NFPA 805 OBSERVATION VISIT TRIP REPORT

Date: March 27-30, 2006

Subject: Risk-Informed, Performance-Based Fire Protection Transition Pilot-Plant Observation Visit - Harris Nuclear Plant and Oconee Nuclear Station

Issue Summary Sheet No. 1

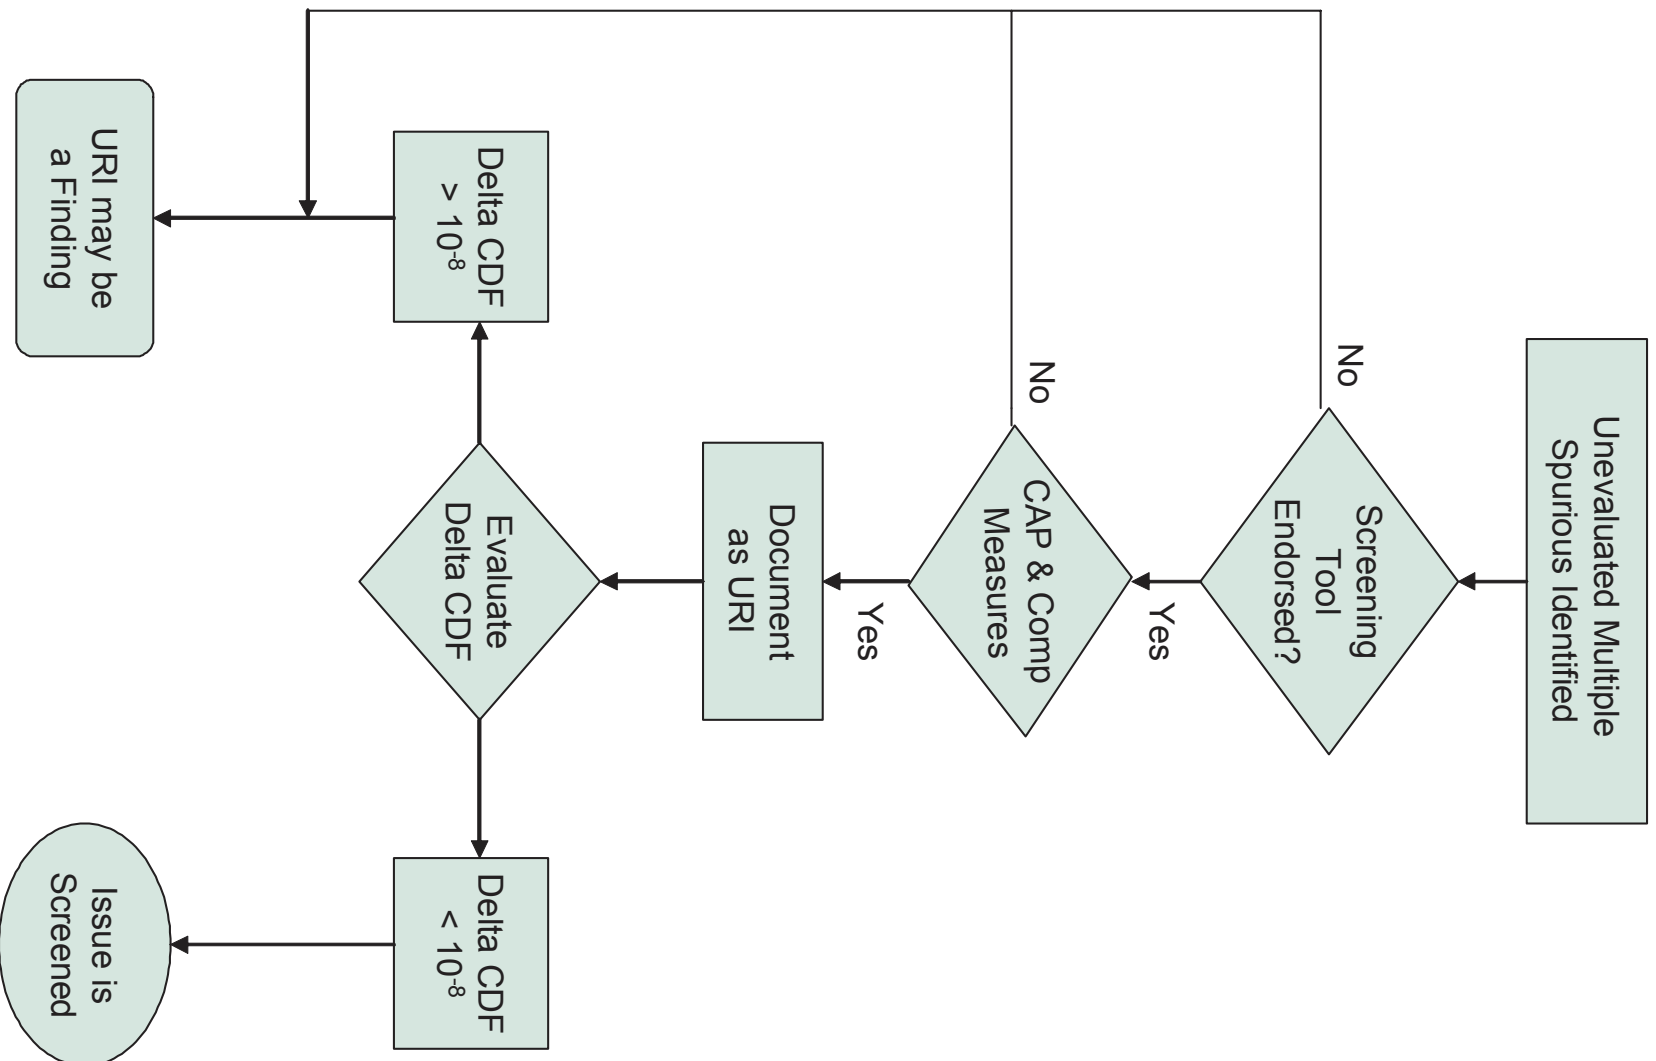
The NRC staff presented a flowchart during the March 2006 pilot plant observation meeting that illustrated how new multiple spurious operations (identified during inspections) would be treated (See flow chart below). In addition to the flowchart, the following information was also conveyed during the meeting:

The process outlined in the flowchart documents (new) unevaluated multiple spurious operations as unresolved items (URIs) and proposes a risk threshold below which the multiple spurious operation is screened (a potential threshold for such “treatment” of 1E-08/yr delta-CDF [1E-09/yr delta LERF] was offered for discussion). Industry raised the concern that documenting all

multiple spurious operations as URIs pending evaluation will create a significant cost and resource impact because all URIs must be formally dispositioned and even those classified as minor can require 1000 hours. Industry's preference would be to not treat the new multiple spurious as a URI, but to disposition the issue within the fire probabilistic safety assessment (PSA) process. Consensus was to review the minor questions in Inspection Manual Chapter (IMC) 0612, and suggest development of new questions if necessary such that multiple spurious operations below a certain threshold could be relegated to minor and treated accordingly.

Resolution Action(s)/Action Party: OPEN. Industry and pilot-plant participants agreed to review the flowchart, IMC 0612 questions, screening thresholds and provide feedback to the NRC at the next observation meeting. The industry may also submit an FAQ on the issue.
